ADDENDUM 1

CSP 23-25

GYMNASIUM ADDITIONS/IMPROVEMENTS FOR CANTERBURY & ESCANDON ELEMENTARY SCHOOLS

PROJECT: Edinburg C. I. S. D.
Gymnasium Additions / Improvements for
Canterbury & De Escandon Elementary Schools
CSP #23-25

8 FRENCH DRAIN

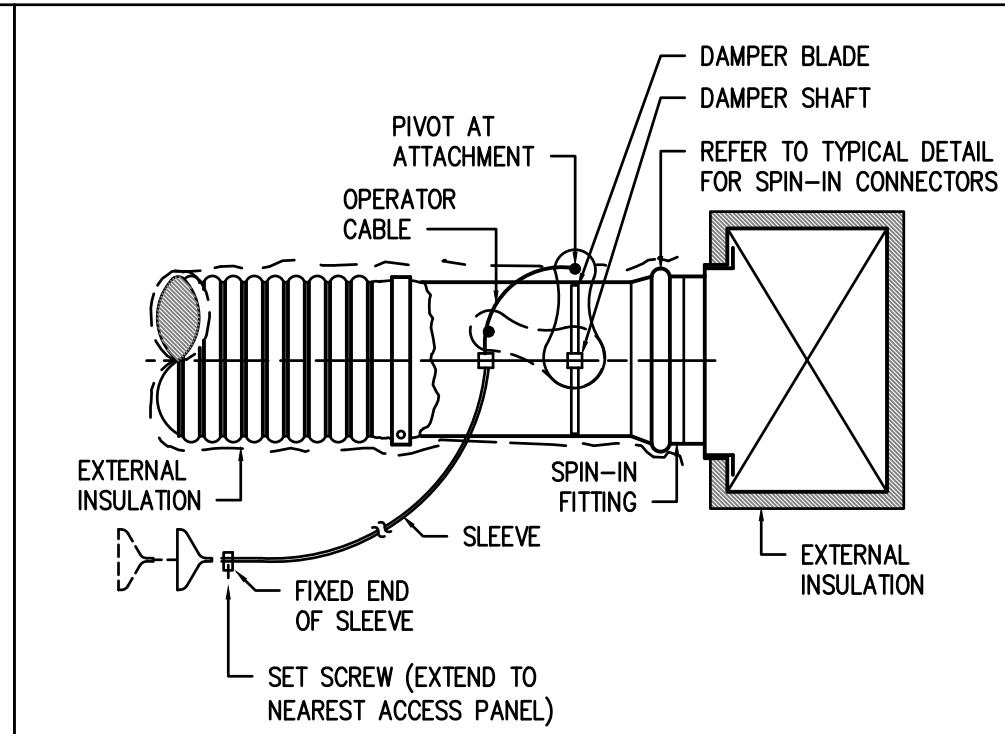
Item 15 Sheet M5.01 – MECHANICAL SCHEDULES AND DETAILS

- H. Added the French Drain Detail.
